## Planning Commission Staff Report

**SUBJECT:** P13-0336

**PURPOSE:** Work Session to review and receive comments on a Preliminary Review application to: (1) replace the existing auto service use with a 24-hour 7-Eleven convenience market and a drive-through carwash; (2) add approximately 700-square feet to the existing building; and (3) modify the existing site improvements at the existing Valero service station.

**LOCATION:** 3192 Santa Rita Road

The Proposed Site Plan

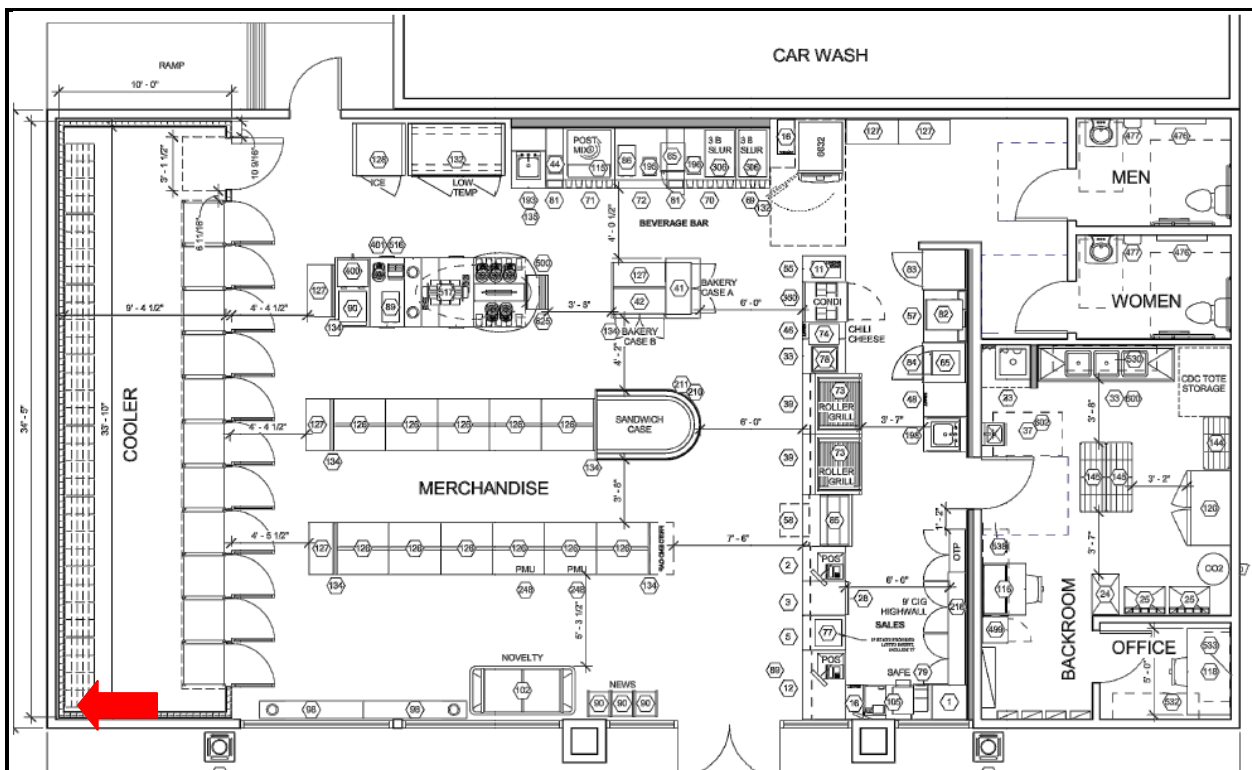
Discussion Point No. 4: Are the proposed site plan, circulation, and parking layout acceptable?

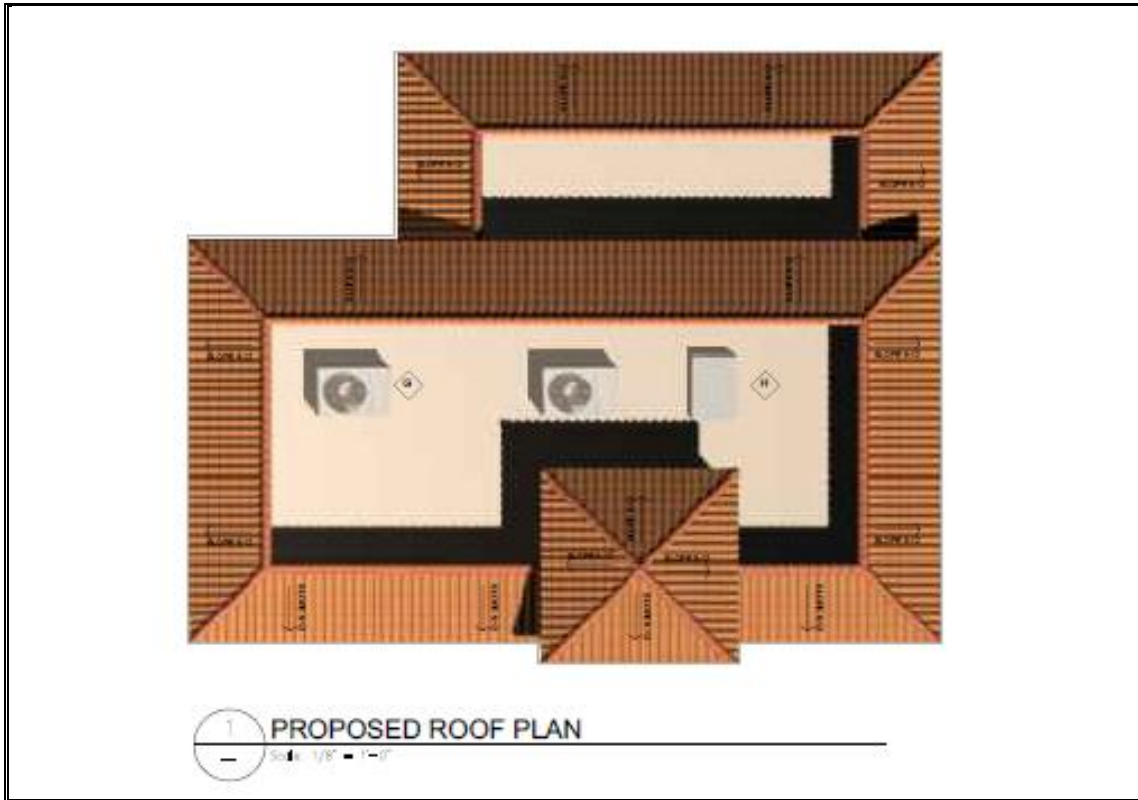
Discussion Point No. 5: Is the proposed building design acceptable?
---
